City of West Linn
PRE-APPLICATION CONFERENCE MEETING
Notes
April 4, 2013

SUBJECT: Three lot minor partition at 23451 Salamo Road

Remington Drive Partition - R1

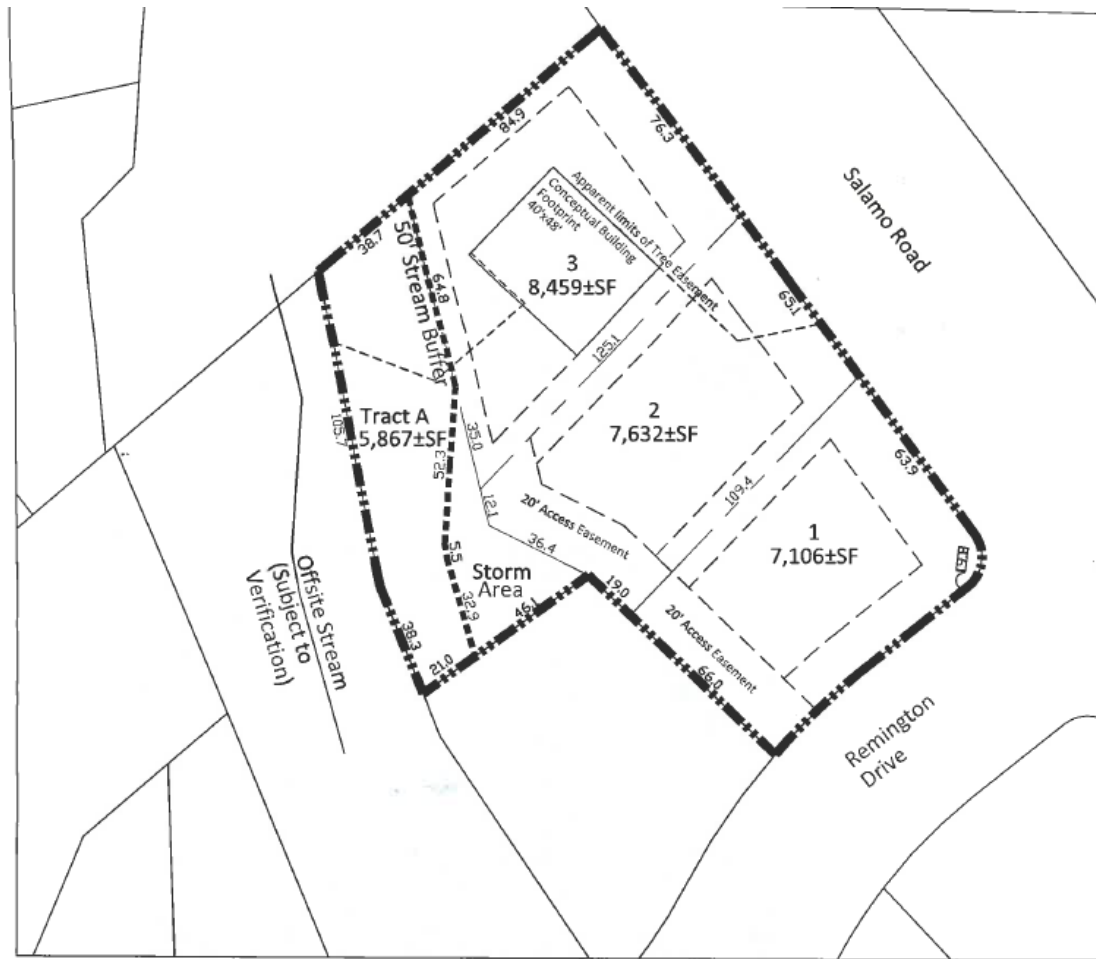
Three lots are proposed for this minor partition. The lots are arranged to maximize their setback from the WRA and show deference to the trees on the north side. Per the R-7 zoning, all lots are over 7,000 square feet in size. According to the applicant's drawings, a storm water treatment and detention pond is proposed within the WRA. (Subsequent discussions at the pre-application conference indicated that individual rain gardens would be installed so as to remove the pond from the WRA.) Access will be via a new curb cut that will replace an existing one on Remington Drive. The interior driveway will extend north towards the rearmost lot. It has yet to be determined if the driveway is in the WRA.

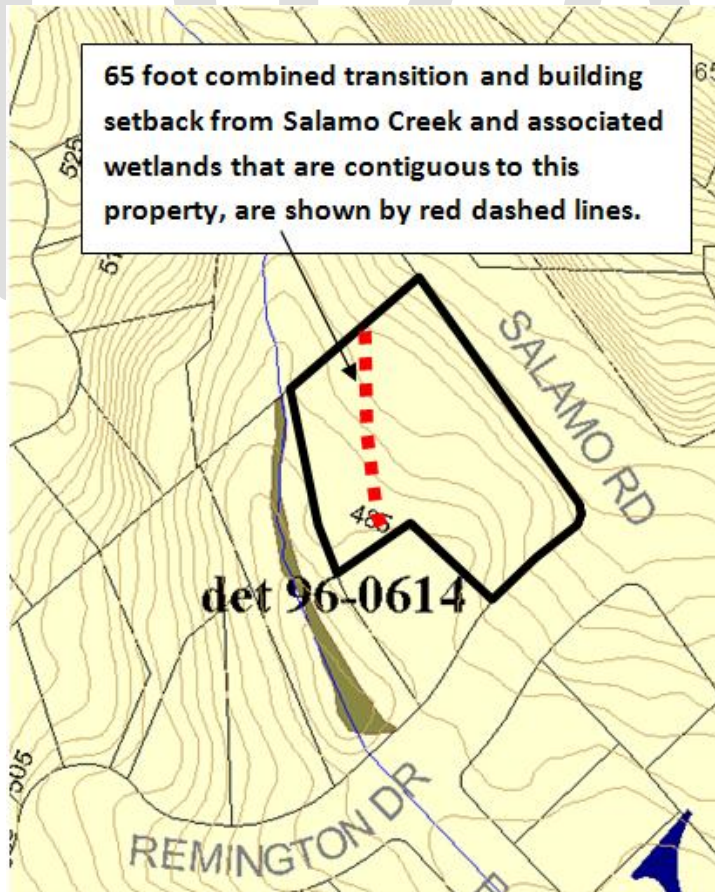
Section 55.100(B)(2) provides for significant tree preservation and can require that up to 20 percent of the non-type I and II lands be set aside for their protection. Significant trees on Type I and II lands are given complete protection. Trees within the WRA (drainageway) boundary are therefore to be saved 100%. The code makes accommodation for the removal of trees in anticipated street alignments (see 55.100(B)(2) exemptions) but the applicant should anticipate being required to mitigate for their loss on an inch by inch basis exclusive of normal street tree requirements. The mitigation can be on or off-site, or can be satisfied by a fee-in-lieu payment, if the Parks

Department agrees to this. Significant trees in the WRA (on Type I and II lands) cannot count towards the fulfillment of the maximum 20 percent set aside for significant trees on non-Type I and II lands.

The applicant's arborist should contact City Arborist Mike Perkins (503-723-2554 or mperkins@westlinnoregon.gov) once the preliminary tree inventory is complete to verify which trees are significant. (Preliminary discussions with Mike Perkins indicate that the Oak tree on the street corner is significant and needs to be saved.)

An existing tree conservation easement required in 2000 is noted on the applicant's partition submittal. That area may be modified in the platting process if it turns out that it does not effectively encompass significant trees or that it may not satisfy the 20% significant tree set aside.
